Village of Cassopolis

CWSRF Interceptor Force Main Replacement

ADDENDUM 1

June 12, 2026

Sheet SR-7.5-6 – E. Division Street Surface Restoration Plans Sta. 20+00 to 30+00

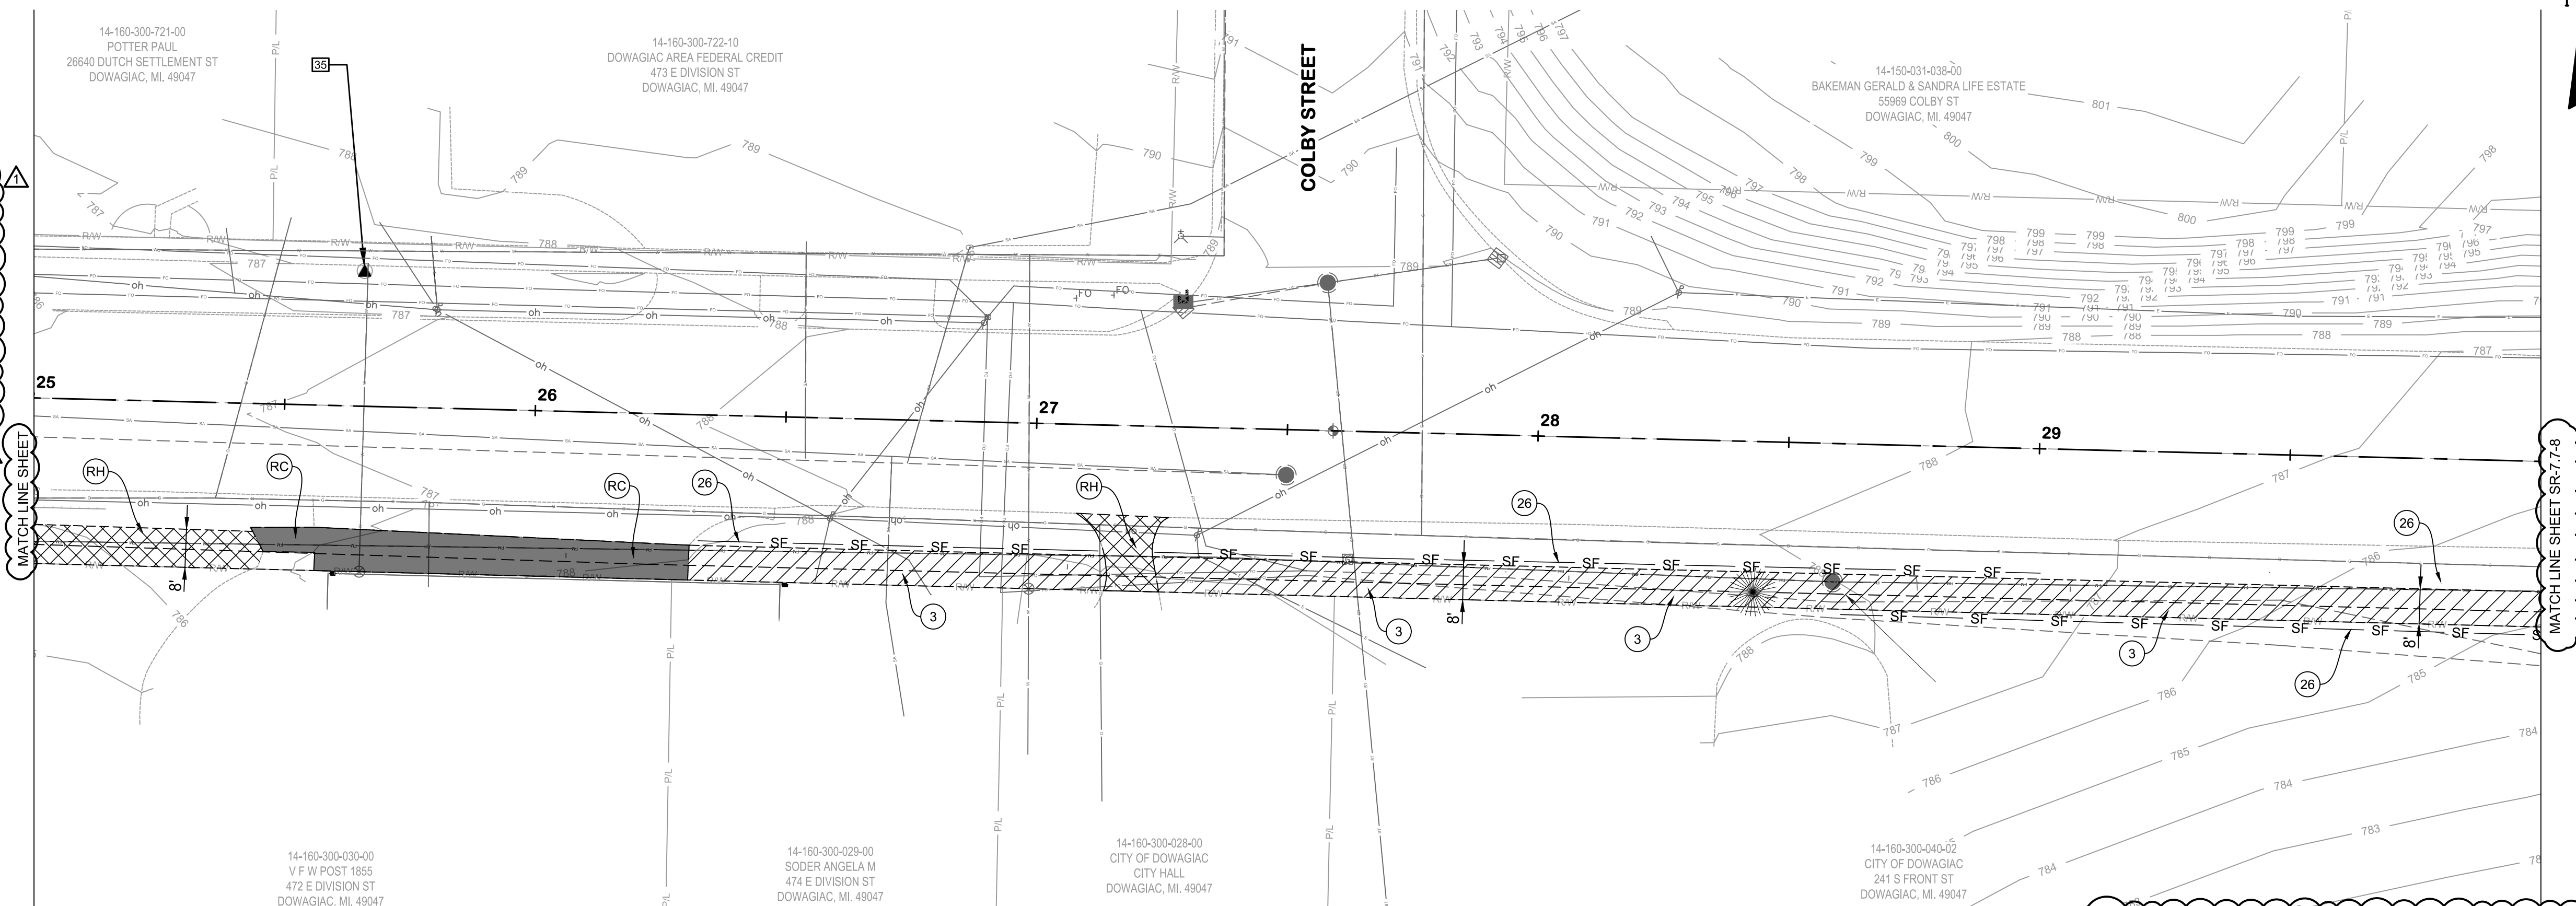
There is layer clean up, minor restoration limit changes, and symbology updated on this sheet. Replace the sheet with the provided Sheet SR-7.5-6 included with Addendum 1.

NOTE:
 1. THERE IS LAYER CLEAN UP, MINOR RESTORATION LIMIT CHANGES, MATCHLINES, SURFACE RESTORATION HATCH LEGEND AND SYMBOLOLOGY UPDATED ON THIS SHEET. REPLACE THE SHEET WITH THE PROVIDED SR-7.5-6 INCLUDED WITH ADDENDUM 1.

Sheet SR-7.7-8 – E. Division Street Surface Restoration Plans Sta. 30+00 to 40+00

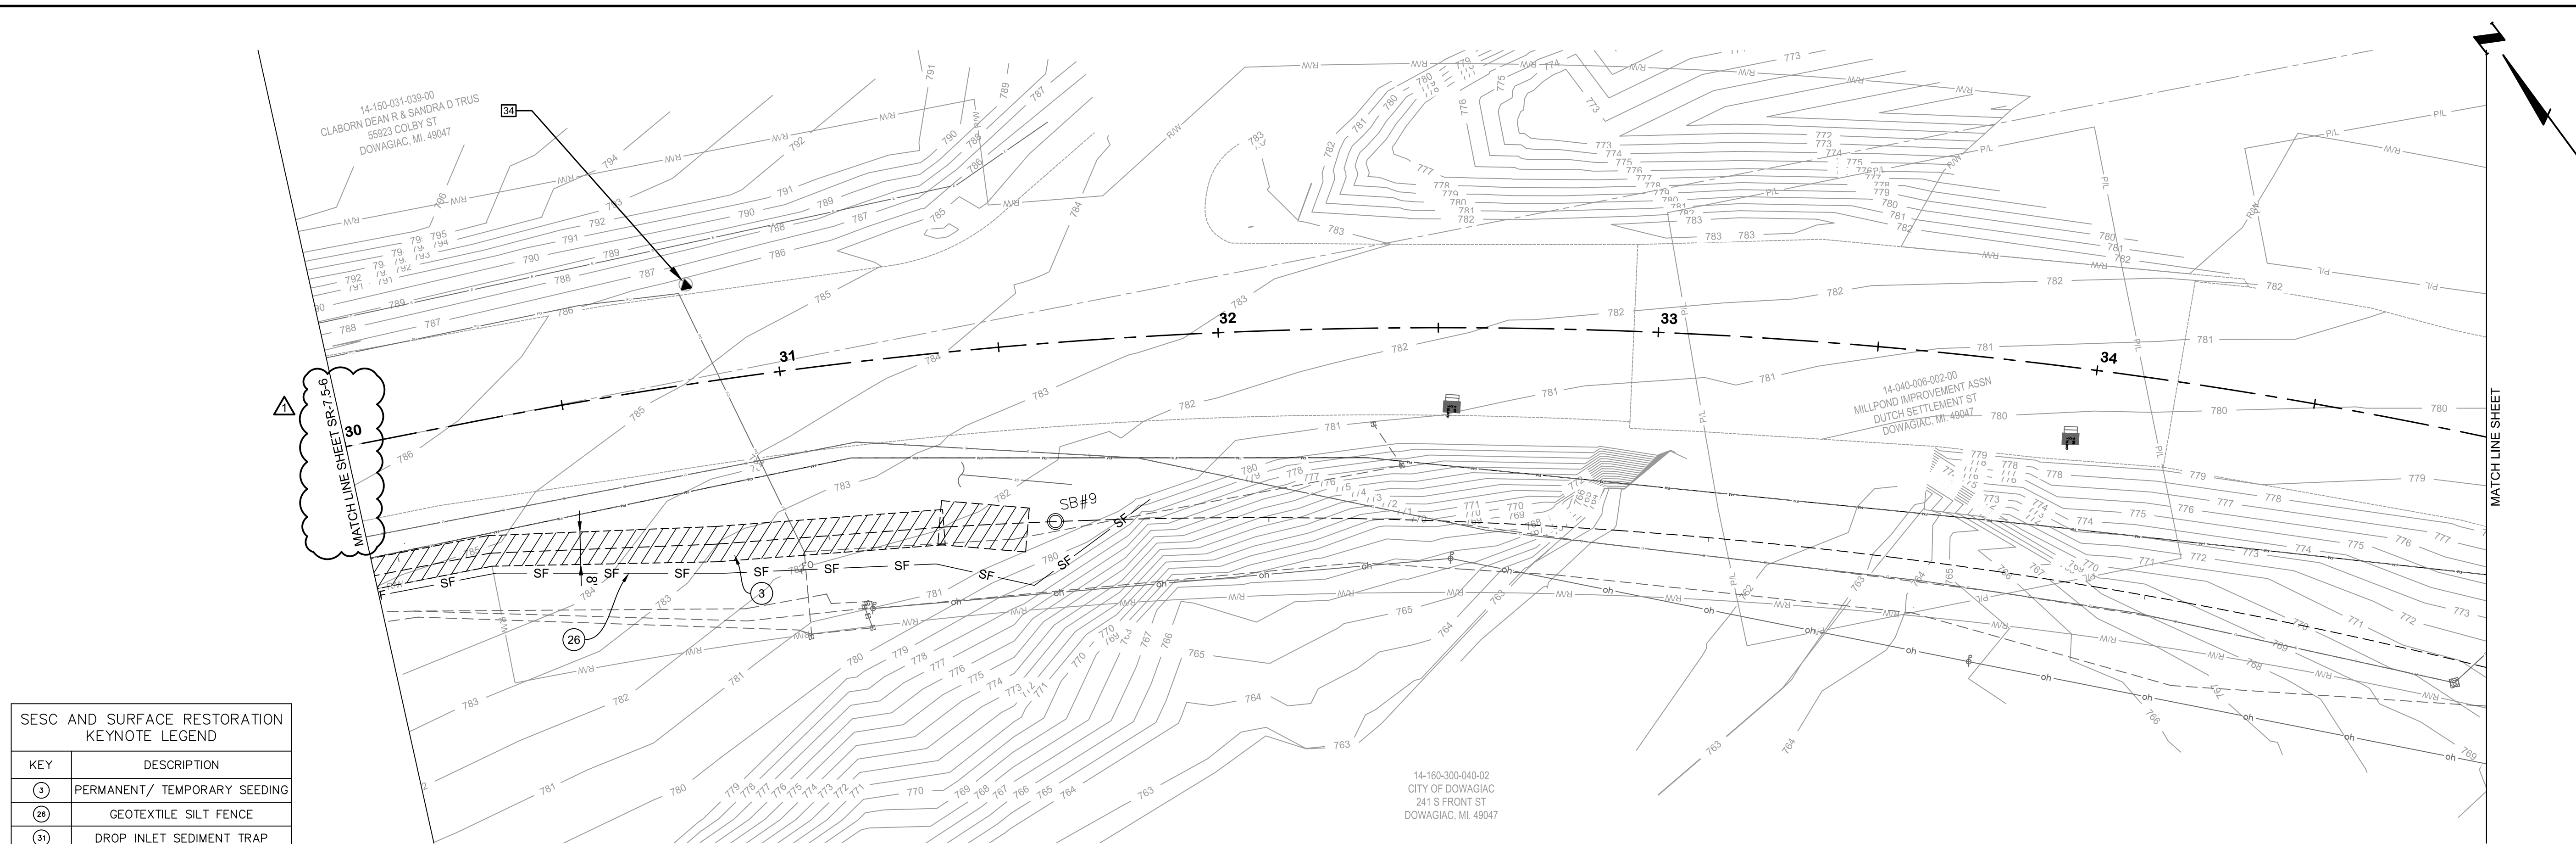
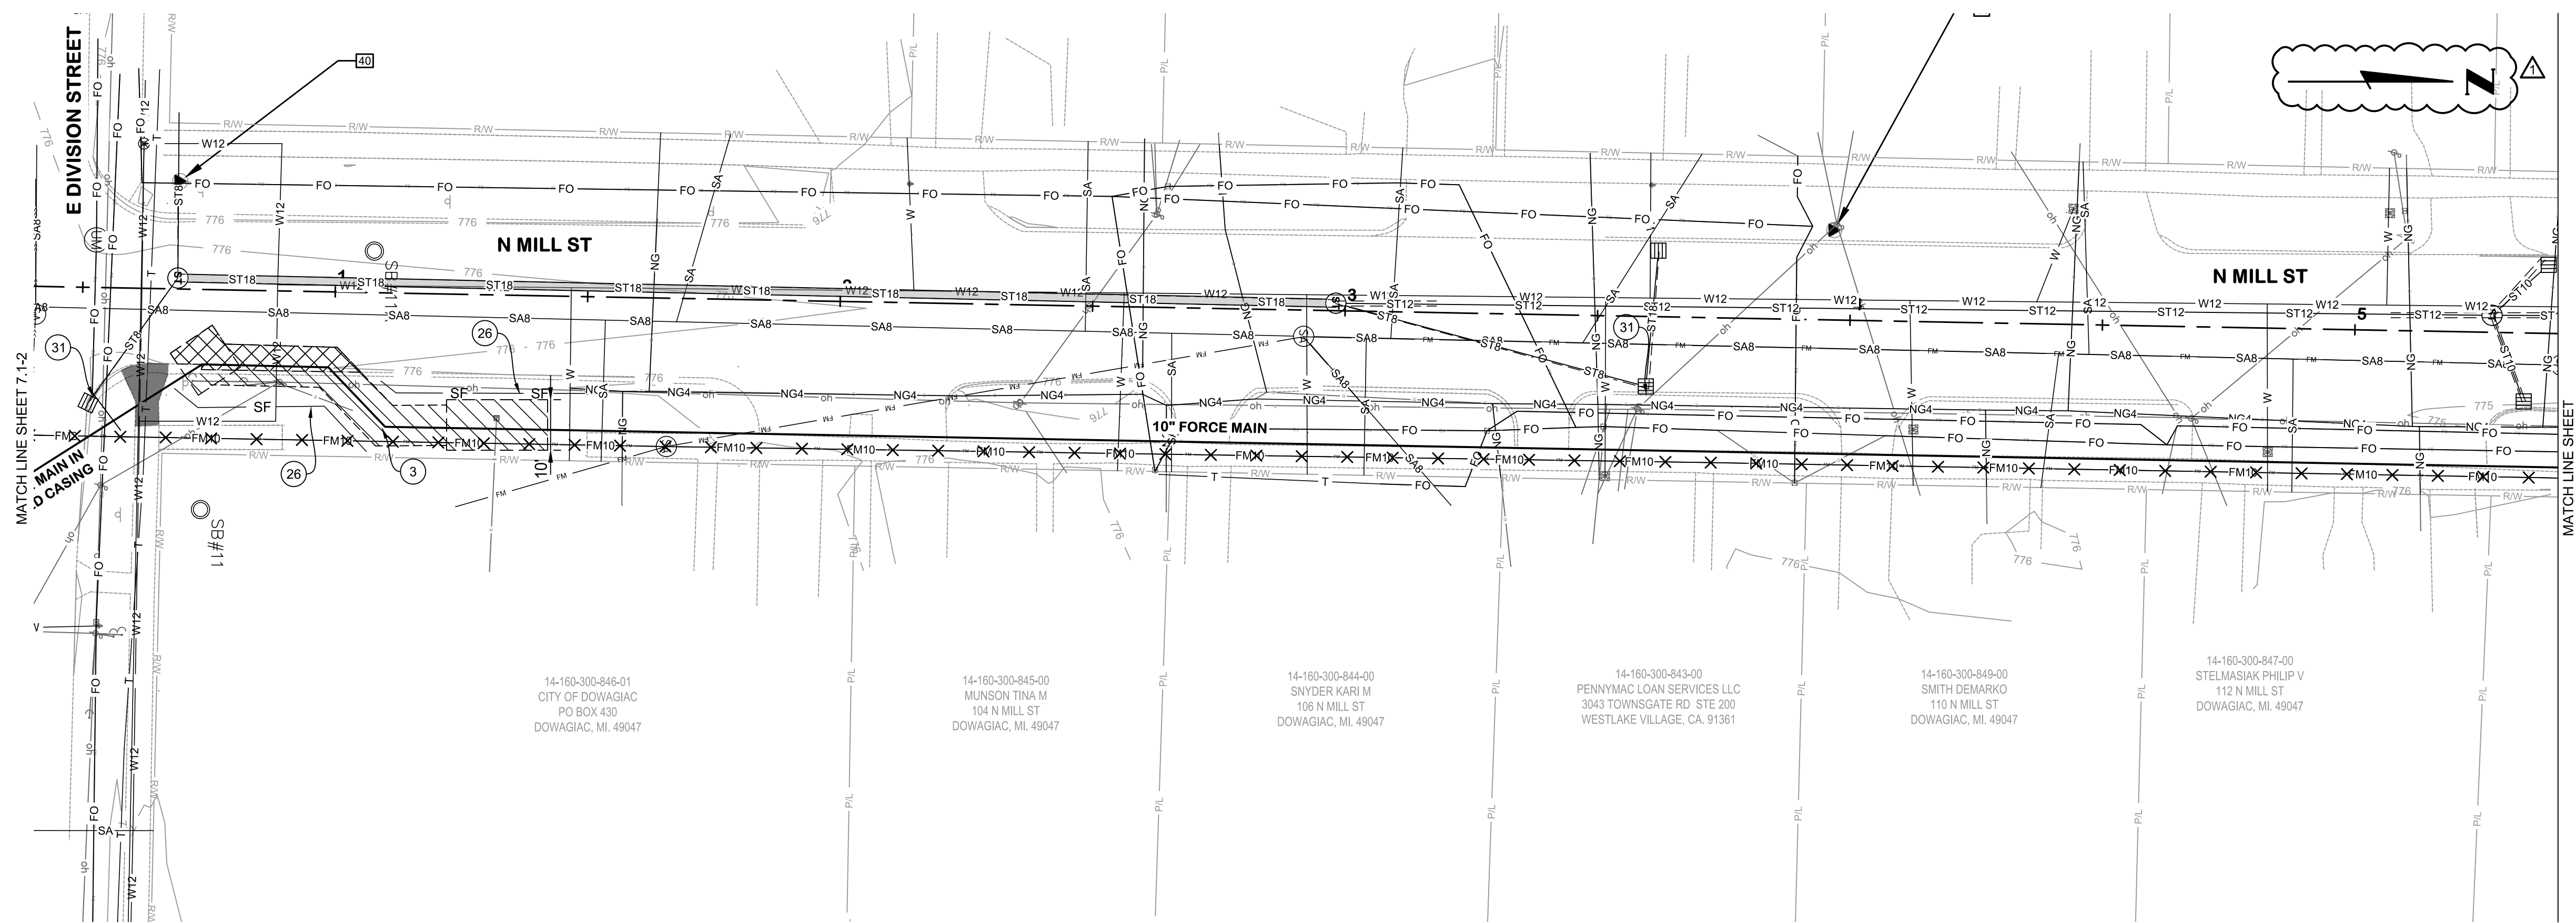
There are minor restoration limit changes on this sheet. Replace the sheet with the provided Sheet SR-7.7-8 included with Addendum 1.

NOTE:
1. THERE ARE MINOR RESTORATION LIMIT CHANGES ON THIS SHEET ALSO MATCHLINES AND SURFACE RESTORATION HATCH LEGEND. REPLACE THE SHEET WITH THE PROVIDED SR-7.7-8 INCLUDED WITH ADDENDUM 1.

Sheet SR-8.1-2 – N. Mill Street Surface Restoration Plans Sta. 0+00 to 10+00

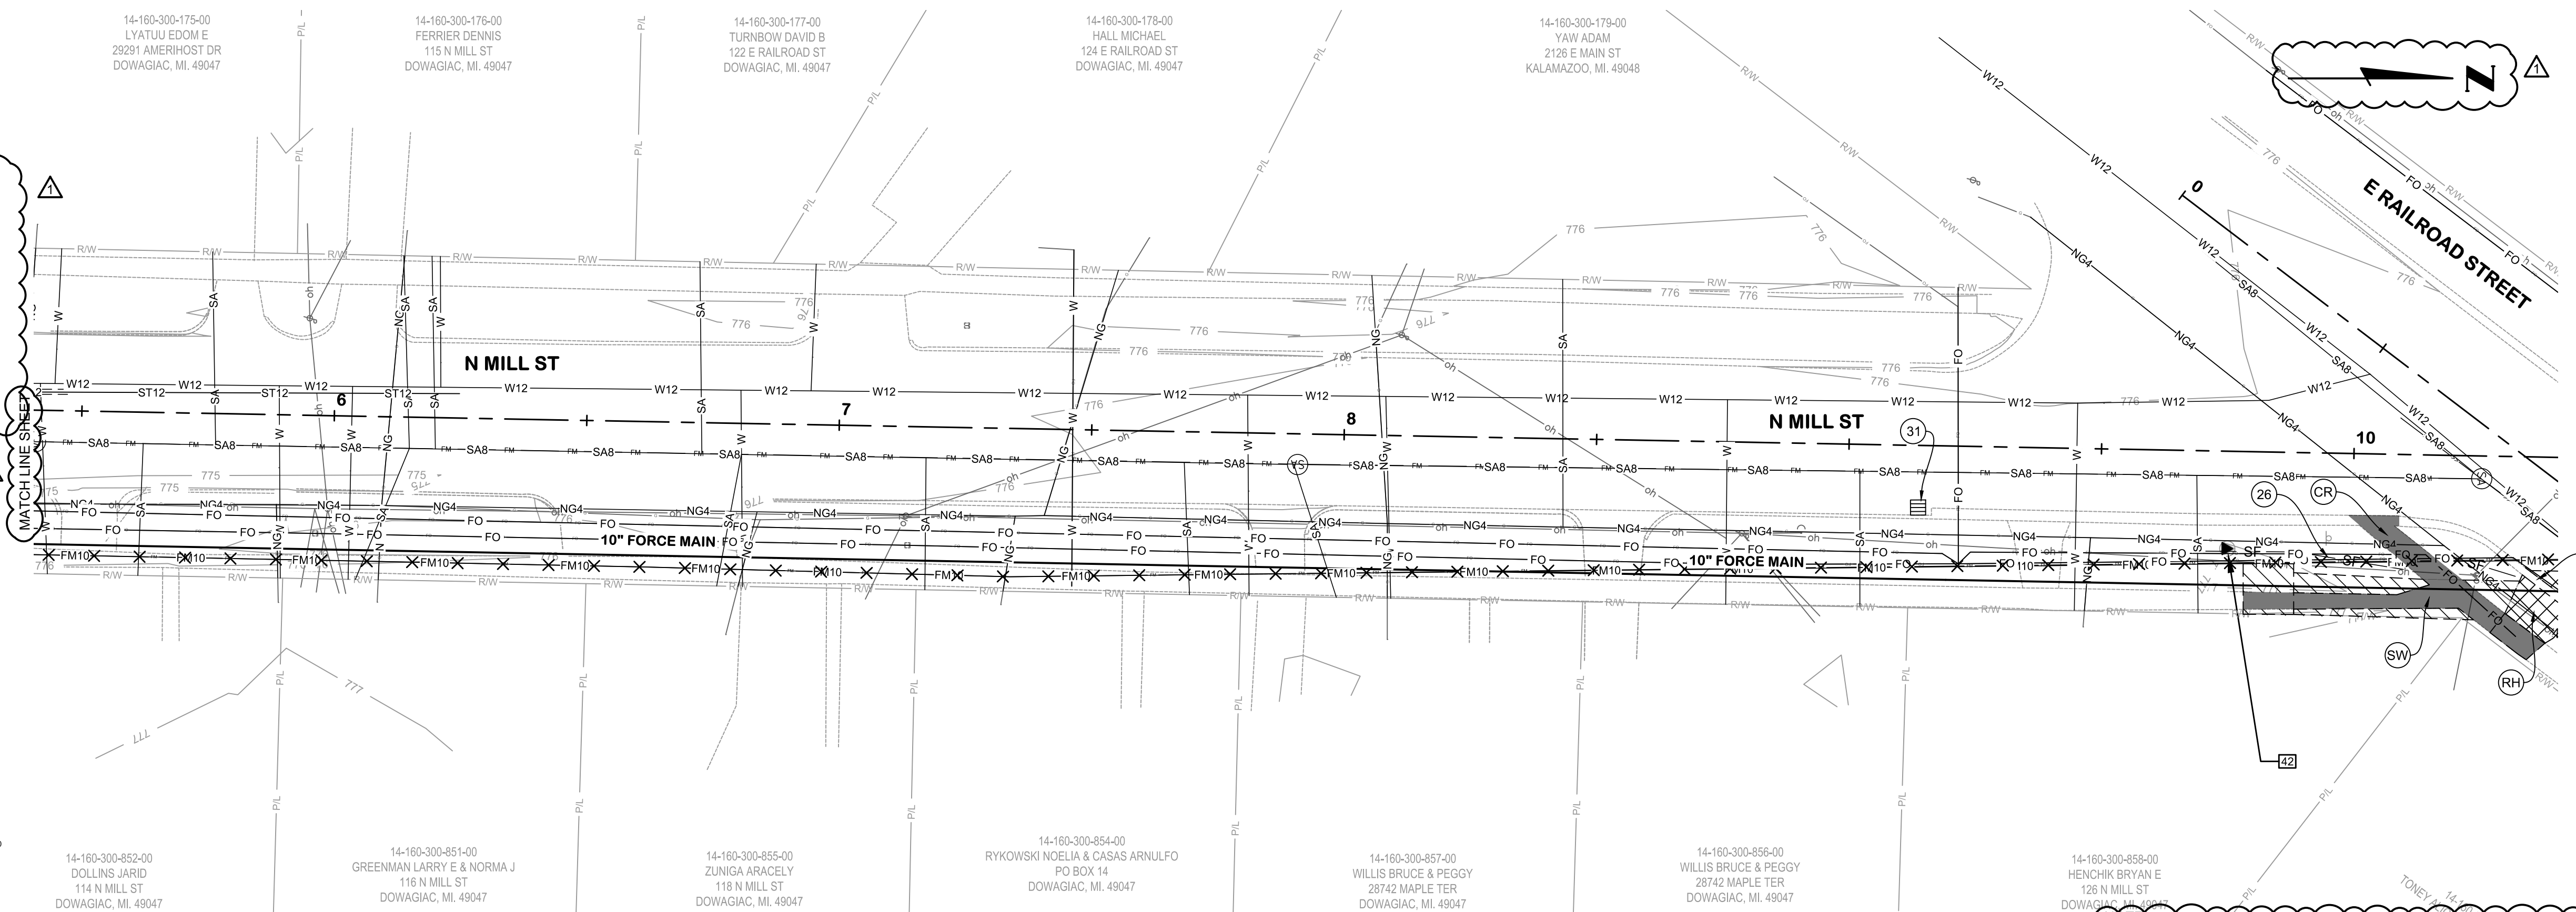
There is layer clean up, restoration limit changes, and match lines as well as north arrows added on this sheet. Replace the sheet with the provided Sheet SR-8.1-2 included with Addendum 1.

Restoration limits have been revised, details have been added, and most restoration items along Mill Street force main installation have been removed due to construction method change from open cut to directional drilling.

NOTE:
1. THERE IS LAYER CLEAN UP, RESTORATION LIMIT CHANGES, SURFACE RESTORATION HATCH LEGEND, MATCH LINES AS WELL AS NORTH ARROWS ADDED ON THIS SHEET. REPLACE THE SHEET WITH THE PROVIDED SB-8.12 INCLUDED WITH ADDENDUM 1.
